# UNITED STATES PATENT AND TRADEMARK OFFICE

APPLICATION NO.	FILING DATE	FIRST NAMED INVENTOR	ATTORNEY DOCKET NO.	CONFIRMATION NO.
10/724,754	12/02/2003	Etienne Galmiche	0512-1190	1809

**Office Action Summary**

## DETAILED ACTION

Figure A. Prior art of Schroter.

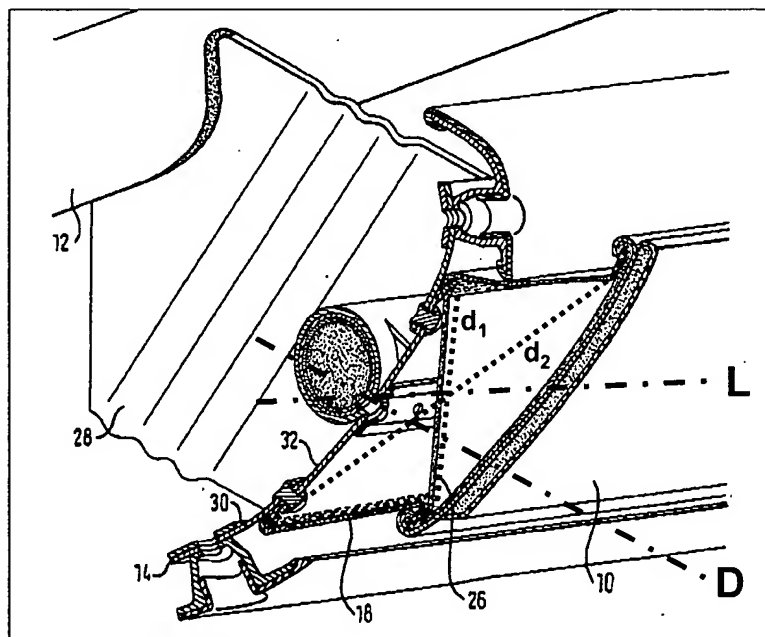
b. The side wall 18 of the structure has a first diagonal  $d_1$  shorter than a second diagonal  $d_2$  of the side wall so that, as the structure deploys, the side wall which is substantially taut along the first diagonal brings the structure towards the median directrix line as shown in Figure A below (column 1, line 56 – column 2, line 11) (claim 2.)

c. When the structure is in the deployed configuration, the side wall 18 extends substantially over its entire periphery along generatrices parallel to the median directrix line L as shown in Figure A below (Fig. 4) (claim 4.)

d. The median directrix line L is intended to be inclined upwards with respect to the direction of inflation D when the set of equipment is installed in a motor vehicle as shown in Figure A (Fig. 4) (claim 5.)
